# Access Compliance Report

## Public Rights-of-Way

Intersection ID: 10017066	Main Street: NEAL_RD	Cross Street: N/A	Location: E
ADA ID: 5FA793B5E84D	Ramp Type: PerpDiag	Initial Pass/Fail: Fail	Overall Compliance: No
Codes/Mitigation Info/Possible Solution		Field Measurements/Component Compliance	
Severity Score: 33.75

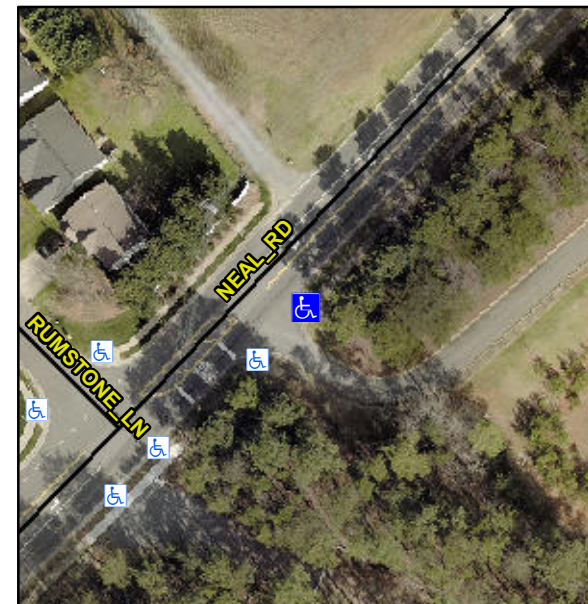
**R304.5.1, R304.2.2**

Compliance	Description	Data	Compliance	Description	Data
N/A	Ramp Length (in)	130.0	No	Ramp Slope (%)	12.0
No	Ramp Width (in)	38.0	Yes	Ramp XSlope (%)	1.7
N/A	Flare Type LT	N/A	N/A	Flare Type RT	N/A
N/A	Flare Slope LT (%)	N/A	N/A	Flare Slope RT (%)	N/A
N/A	Flare Traversable LT?	N/A	N/A	Flare Traversable RT?	N/A
N/A	Landing Length (in)	N/A	N/A	DWS Provided?	N/A
N/A	Landing Width (in)	N/A	N/A	DWS Contrast?	N/A
N/A	Landing Slope (%)	N/A	N/A	DWS Length (in)	N/A
N/A	Landing X Slope (%)	N/A	N/A	DWS Full Width?	N/A
N/A	Landing Curb? (Y/N)	N/A	N/A	DWS Offset (in)	N/A
N/A	Shared Landing?	N/A			
N/A	Gutter Ponding?	N/A	N/A	Gutter Slope (%)	N/A
N/A	Gutter Lip Ht (in)	N/A	N/A	Gutter X Slope (%)	N/A
N/A	Painted X Walk1?	No	N/A	Painted X Walk2?	No
	X Walk 1 Direction	To NW		X Walk 2 Direction	To SW
N/A	X Walk 1 Width (in)	N/A	N/A	X Walk 2 Width (in)	N/A
	X Walk 1 Slope (%)	7.3		X Walk 2 Slope (%)	3.1
	X Walk 1 X Slope (%)	2.9		X Walk 2 X Slope (%)	8.9

**Remove & Replace Curb Ramp With Two New Directional Ramps or Equivalent.**
